FIRST INTERSTATE BANK
21st & K St
OFFICE # 704

Subject: PARKING LOT ON THE NORTH SIDE OF K STREET BETWEEN 20TH AND 21ST STREETS (DR 90-333)

SUBJECT: Parking Expansion for First Interstate Bank
21st & K Branch Office
(APN: 007-0085-009,010) (DR90-333)

Subject: Appeal of Design Review Conditions of Approval For A Parking
Lot On The North Side of K Street, between 20th & 21st Streets
(DR90-333)

PLANTING PLAN

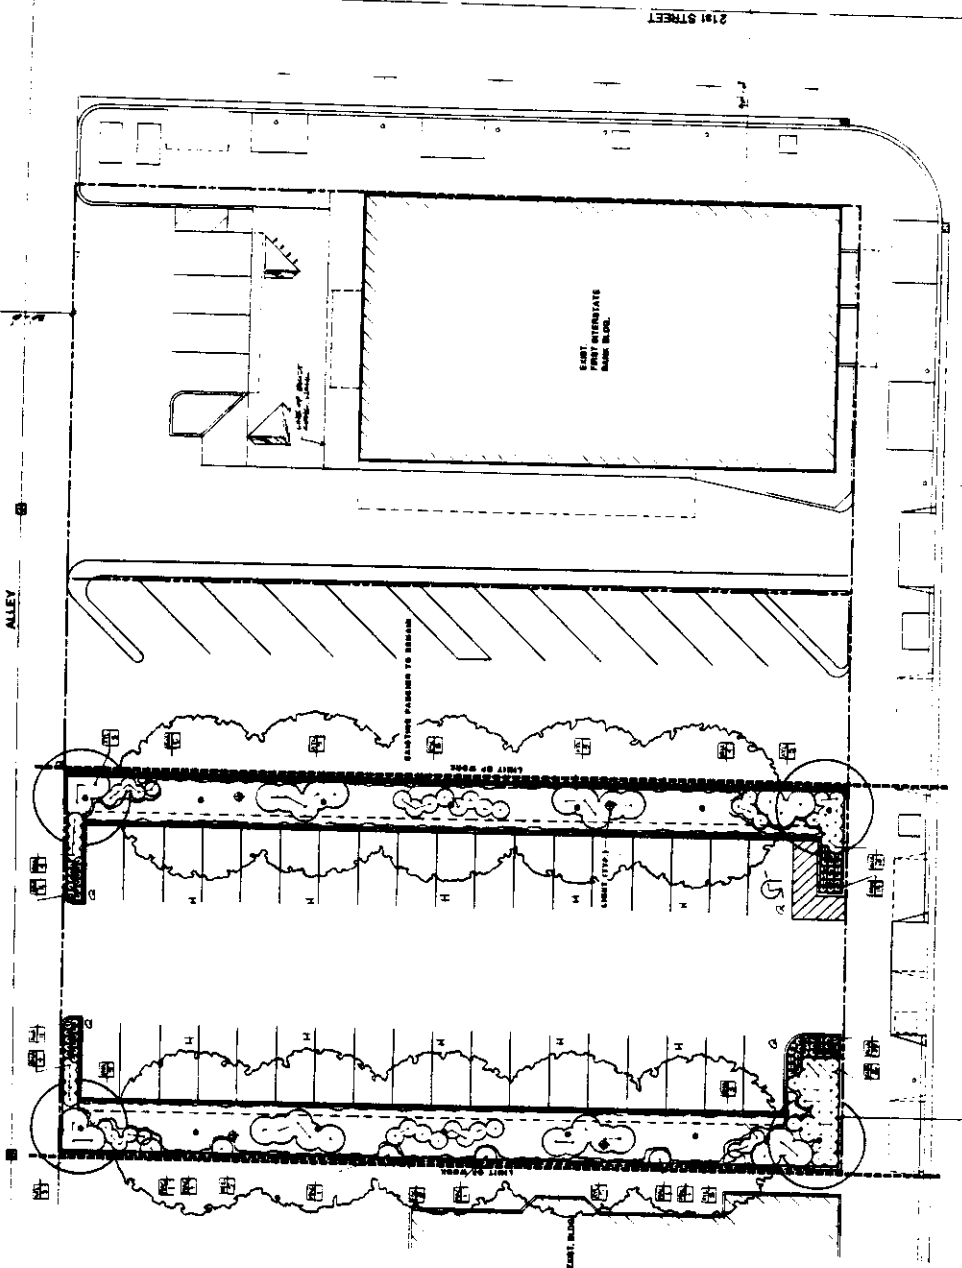
2. The landscaping proposed for the planter along the K Street frontage will include plantings that have maximum heights of only 12"-15" for the foliage clumps of the agapanthus and not much more than two feet for the raphiolepis, for the varieties chosen, according to Western Garden Book. Staff would prefer alternative plantings with higher and denser growth that will provided a greater screening effect.

- 5. The landscaping in the planter fronting the K Street right-of-way shall be revised to provide somewhat higher and somewhat denser screening of the parking lot. A walkway shall be provided between the new parking and the public sidewalk. Final landscape and irrigation plans shall be submitted for the review and approval of both the Board landscape architect member and staff.

SITE PLAN

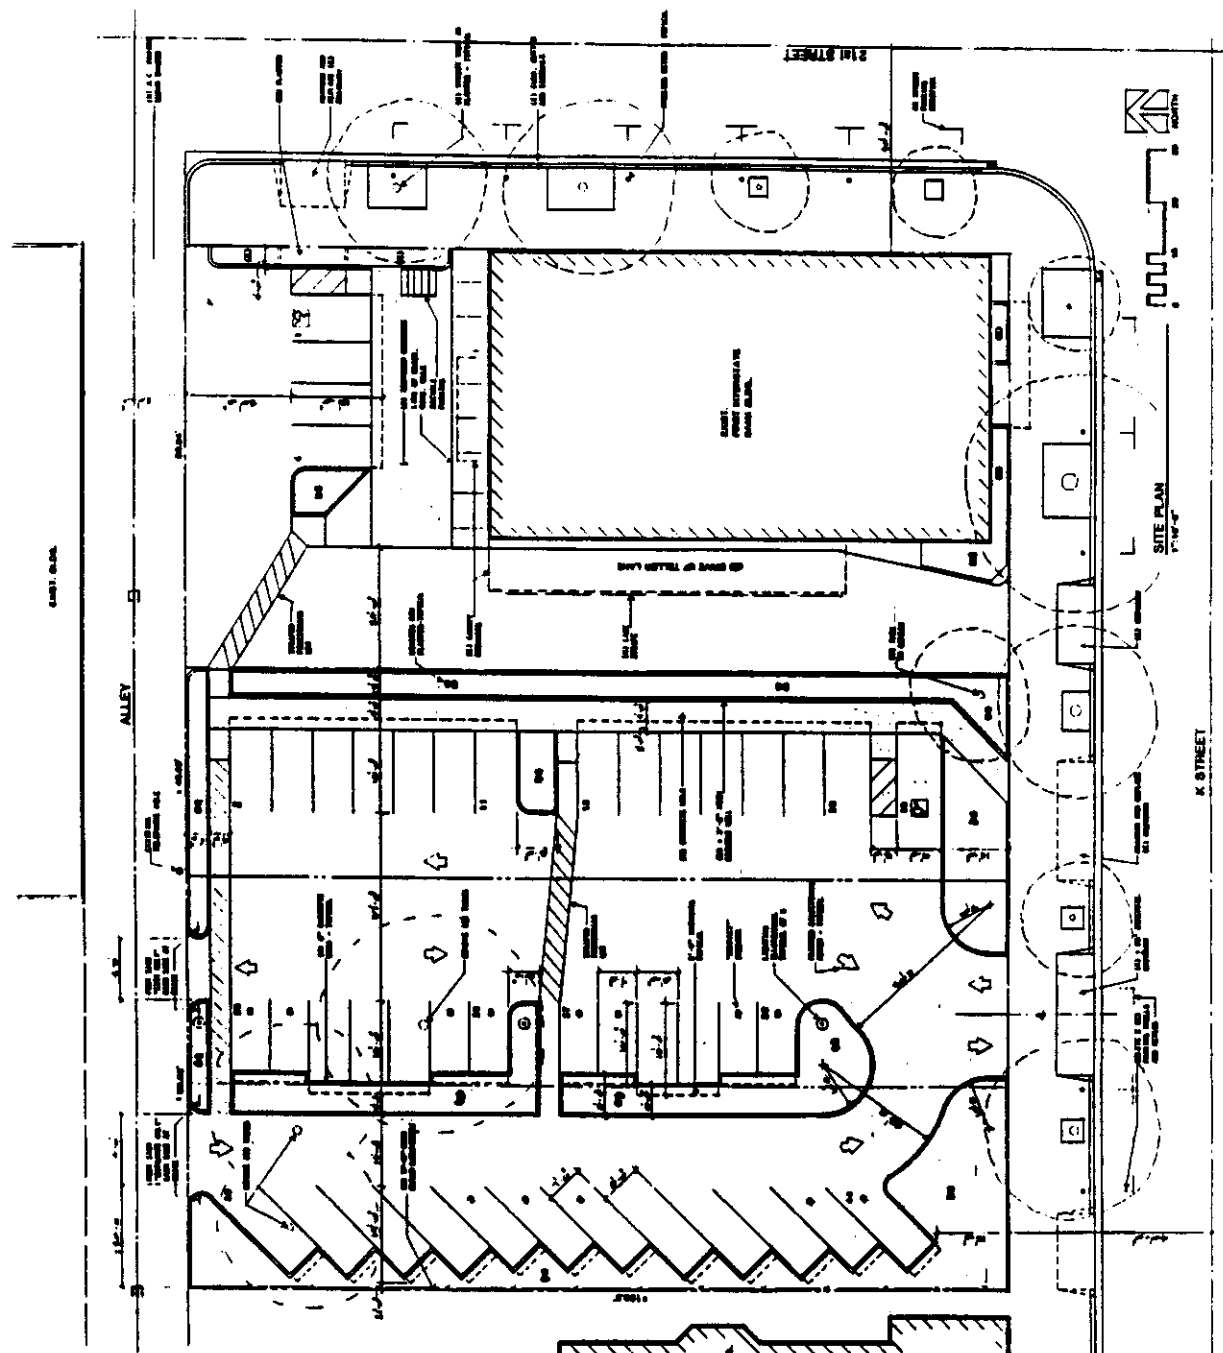
The driveway as shown on applicant's proposed parking lot will require the use of K Street for the circulation between the existing parking and proposed parking lot, thus creating traffic operations problems on the street.

The Transportation Division recommends the denial of the proposed driveway and the closure of all existing driveways adjacent to the proposed parking lot on K Street and the redesigning of the parking lot to provide circulation on site between the two parking lots.

1. Instead of providing cross access with the existing parking, the proposed project is designed with both alley access and direct street access, by way of a repositioned driveway location on the K Street frontage. That repositioning will result in the loss of a street tree. It appears from staff observation that an onsite tree near the alley will also be lost. The lack of cross access between the three parking lots may result in instances of customers exiting onto K Street to simply enter the adjacent lot in search of an available parking space.

An alternative would be to retain the present position of the driveway in order to save the street tree. Or, by eliminating driveway access to K Street from the new lot, not only would the street tree be save, but also the exiting and reentering of vehicles between the two adjacent lots via K Street would be precluded. For those reasons, the latter is the preference of staff.

The double loading of parking on a straight drive from K Street back to the alley will expose two uninterrupted rows of parking spaces to view from K Street. Unless the driveway is eliminated, the line of sight needs to be foreshortened by a finger planter located halfway down each row of 18 spaces.

1. The driveway, as proposed by the applicant, will eliminate an existing street tree.
2. The project, as proposed by the applicant, will place three driveways across the sidewalk and onto the street in the first 190 feet from 21st Street.

3. Cars entering the a new parking lot from K Street and finding the lot full, will need to exit onto the alley, drive south on 21st Street, turn east on K Street and then enter the existing parking lot to secure a vacant parking space.

4. Cars entering the new parking lot from the alley and finding the lot full, will need to exit onto K Street, cross the east lane of traffic, turn west and then attempt to turn left again to enter the existing parking lot to secure a vacant parking space.

- 1. There shall be no direct access between the new parking lot and K Street. Cross access between parking lots is encouraged. Redesign is subject to staff review and approval.

- 3. If driveway access on K Street is permitted, a finger planter shall be located halfway back along each row of parking to effectively foreshorten the view of the parking from the K Street driveway opening.

5. Staffs conditions to remove the K Street driveway to the new parking lot and to place a connector drive between the new lot and the existing lot will:

- A. Save a street tree.
 - B. Reduce curb breaks and cross sidewalk auto traffic.
 - C. Eliminate the need to use the city streets or alley for access between the new and existing parking lots.
